ENGINE - FUEL AND CONTROL - INTRODUCE A REPOSITIONED FCOC FUEL FLOW RESTRICTOR AND
ASSOCIATED FUEL TUBES - CATEGORY CODE 6 - MOD.ENG-73-0078

V2500-ENG-73-0078

Schematic view of fuel tubes - Before and after alteration
Fig.2

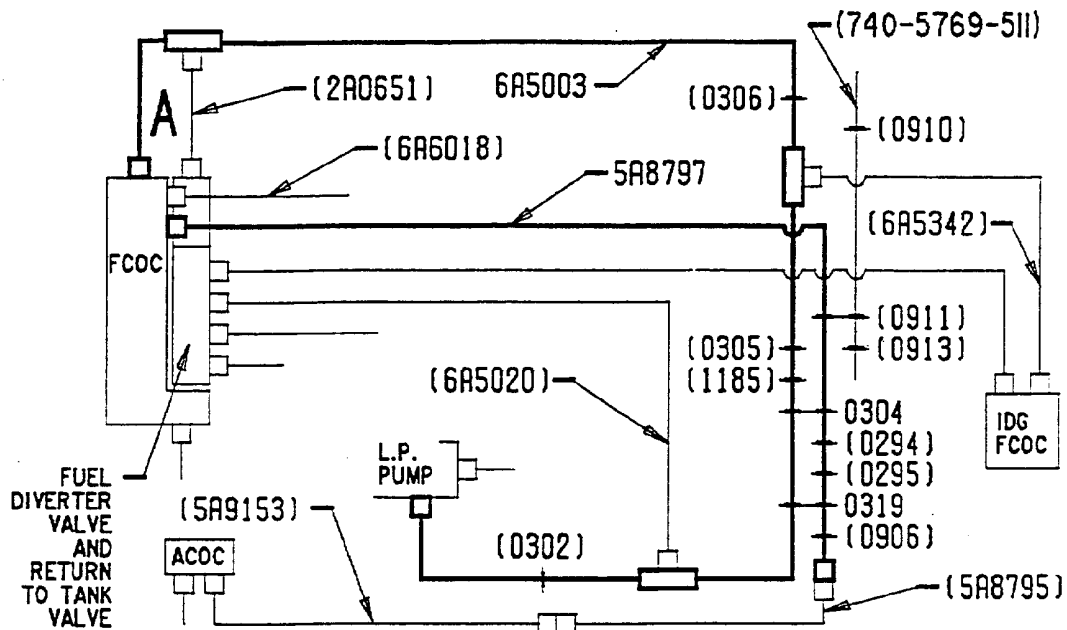
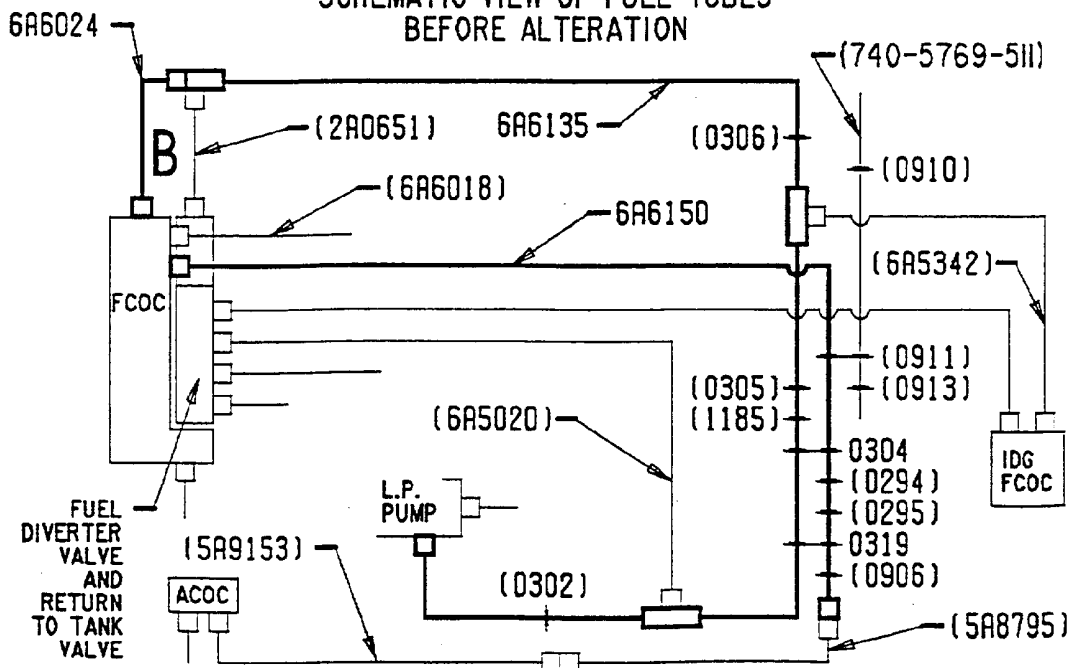
The existing L.P. fuel pump to F.C.O.C. fuel inlet tube assembly is replaced by two tube assemblies. The first tube runs from the L.P. fuel pump to the connector for the return to tank valve tube and the second tube runs from this connector to the F.C.O.C. fuel inlet. The fuel flow restrictor has been redesigned to prevent incorrect assembly and its location changed from the F.C.O.C. inlet end of the existing tube to the return to tank valve tube connector end of the new F.C.O.C. fuel inlet tube.

One of the existing A.C.O.C. to F.C.O.C. oil tubes has also been rerun to accommodate the new fuel tubes.

- (1) To disassemble the existing assembly refer to Engine Manual.
- (2) Install a new AS43013-124 sealing ring, lubricated with CoMat 10-038 Petroleum Jelly or CoMat 10-060 Liquid Paraffin on to the new 6A6135 fuel tube. Install the 6A6135 fuel tube on to the LP fuel pump using the existing bolts. Torque the bolts to 85 to 105 lbfin (10 to 12 Nm). Refer to Figure 2.

- (3) Connect the 2A0651, 6A5020 and 6A5342 fuel tubes to the 6A6135 fuel tube. Torque the 2A0651 and 6A5342 tube union nuts to 566 to 611 lbfin (64 to 69 Nm). Torque the 6A5020 tube union nut to 159 to 177 lbfin (18 to 20 Nm). Safety the tube union nuts with CoMat 02-126 lockwire. Refer to Figure 2.

- (5) Install a new AS43013-118 sealing ring lubricated with CoMat 10-039 lubricant (engine oil) on to the new 6A6150 oil tube. Install the 6A6150 oil tube on to the F.C.O.C. Torque the bolts to 85 to 105 lbfin (10 to 12 Nm). Refer to Figure 2.

- (6) Connect the 6A6150 oil tube to the 5A8795 oil tube. Torque the tube union nut to 478 to 513 lbfin (54 to 58 Nm). Safety the union nut with CoMat 02-126 lockwire. Refer to Figure 2.

- (7) Assemble clipping points 0302, 0906, 0295, 0294, 1185, 0305, 0911 and 0306 on to the new 6A6135 and 6A6150 tubes, using the existing material. Torque the bolt at each clipping point to 36 to 45 lbfin (4 to 5 Nm). Refer to Figure 2.

View at B on Figure 2 - After alteration
Fig.4

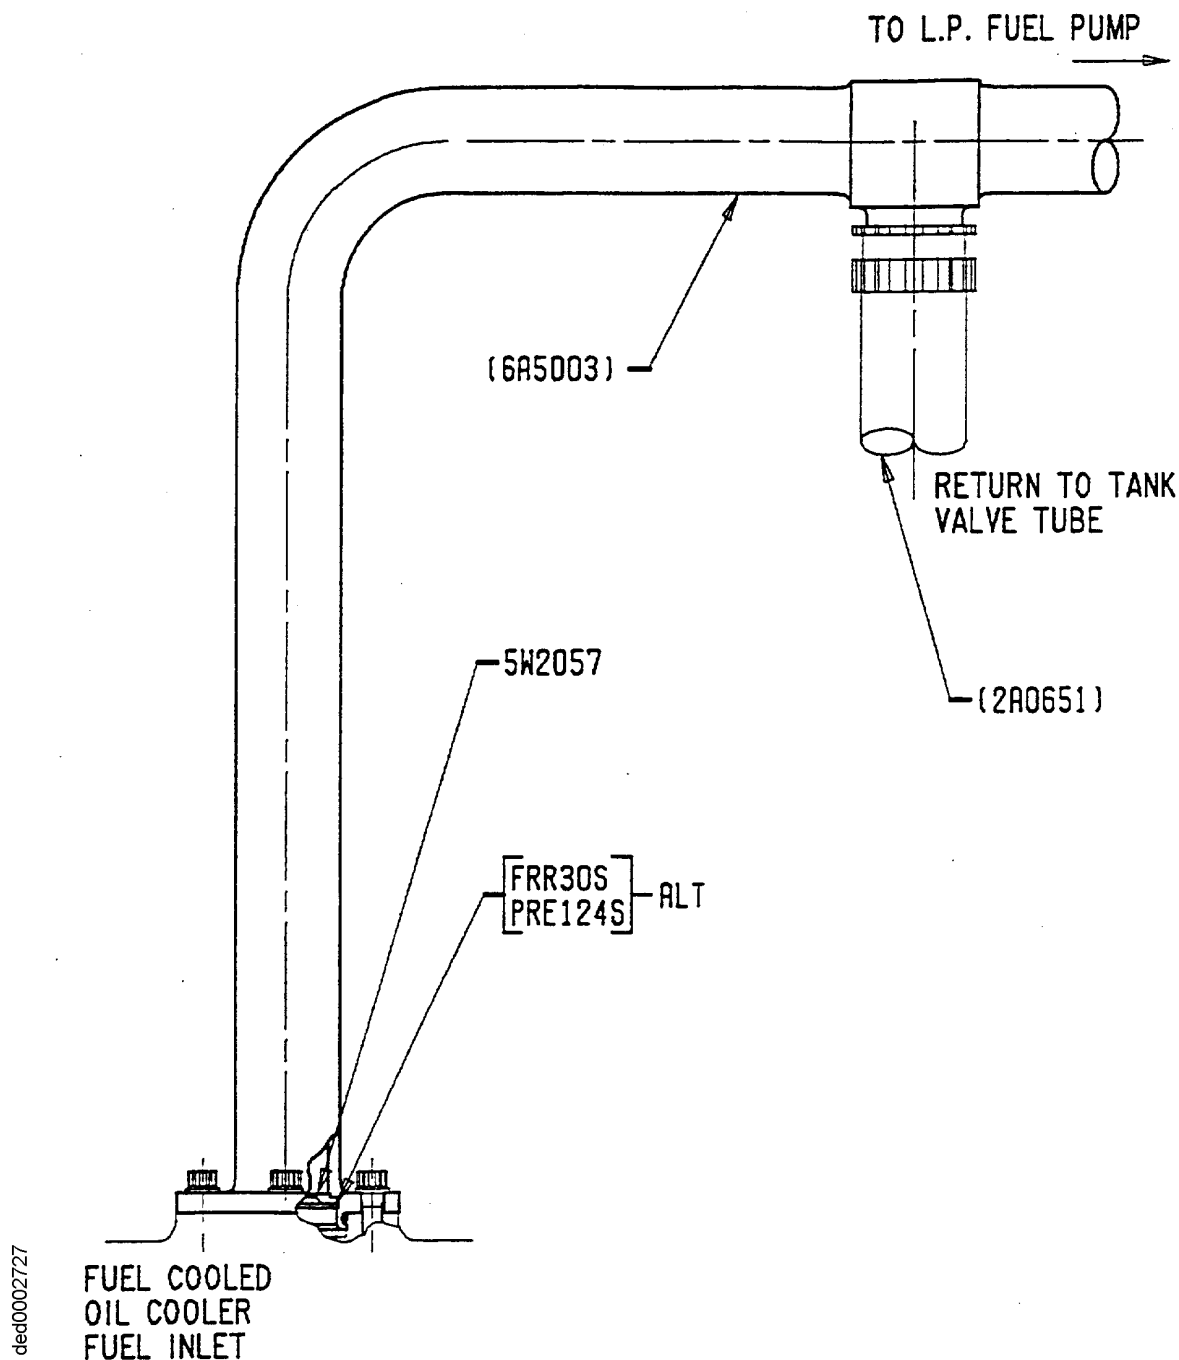
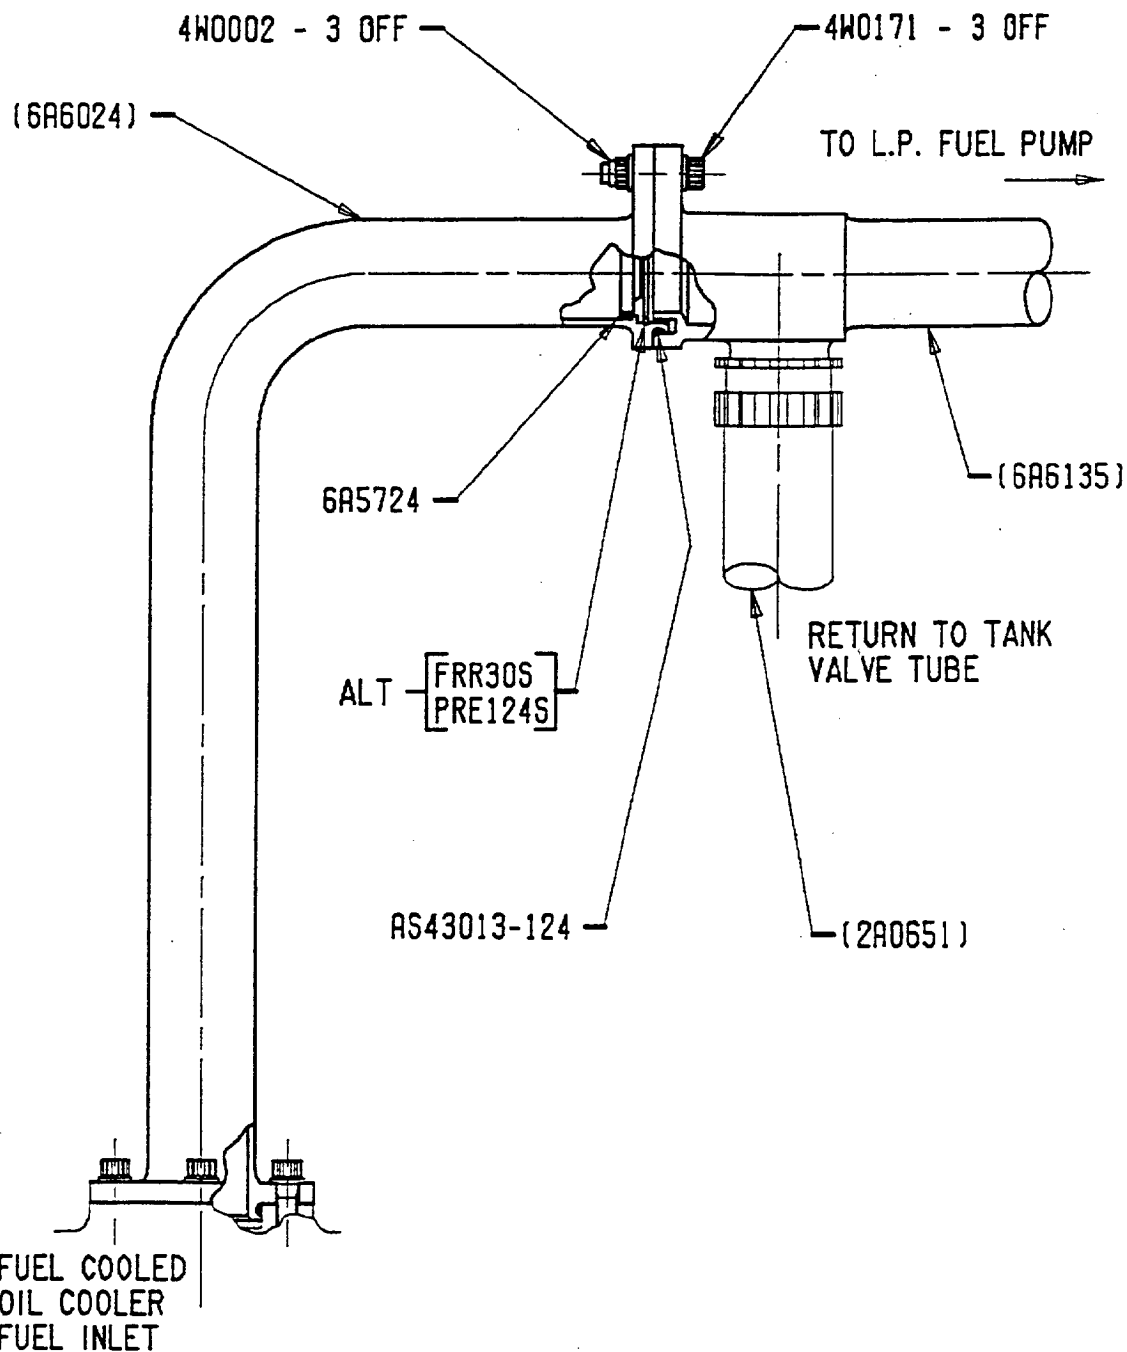
Rig tests have established that the new position of the fuel flow restrictor will alleviate the effects of direct debris impingement on the F.C.O.C. matrix. The addition of spigots on the pipe end connector and the fuel flow restrictor ensures against incorrect fitment.

- (4) Install the new 6A5724 restrictor, FRS30S or PRE124S retainer and two new AS43013-124 sealing rings lubricated with CoMat 10-038 Petroleum Jelly or CoMat 10-060 Liquid Paraffin on to the new 6A6024 fuel tube. Connect the 6A6024 fuel tube to the 6A6135 fuel tube using the 4W0171 bolts (3 off) and 4W0002 nuts (3 off). Install the 6A6024 fuel tube on to the F.C.O.C. using the existing bolts. Torque these and the 4W0171 bolts to 85 to 105 lbfin (10 to 12 Nm). Refer to Figures 2 and 4.

Clipping point 0304 - Before and after alteration
Fig.5

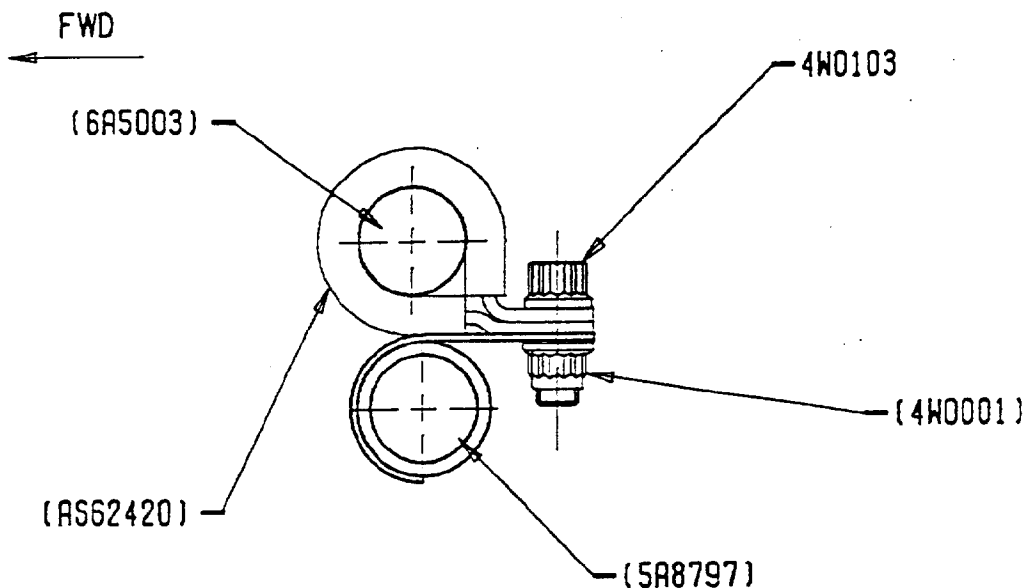
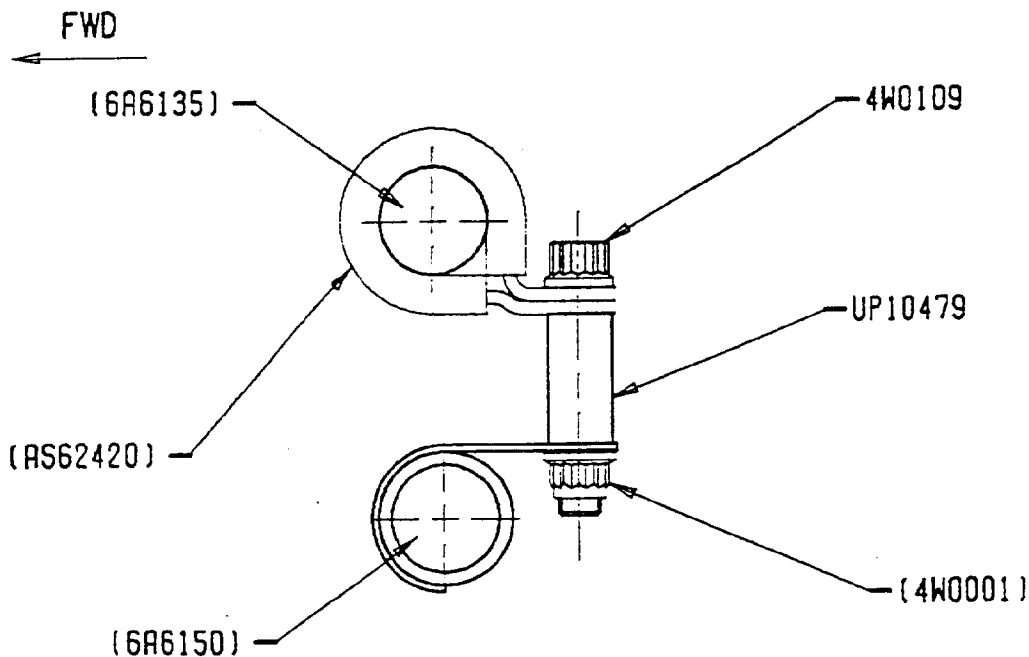
Clipping points 0304 and 0319 have had spacers added to suit the new tube arrangement.

- (8) Assemble clipping point 0304 on to the new 6A6135 and 6A6150 tubes, incorporating the new UP10479 spacer, the 4W0109 bolt and the remaining existing material. Torque the bolt to 36 to 45 lbfin (4 to 5 Nm). Refer to Figures 2 and 5.
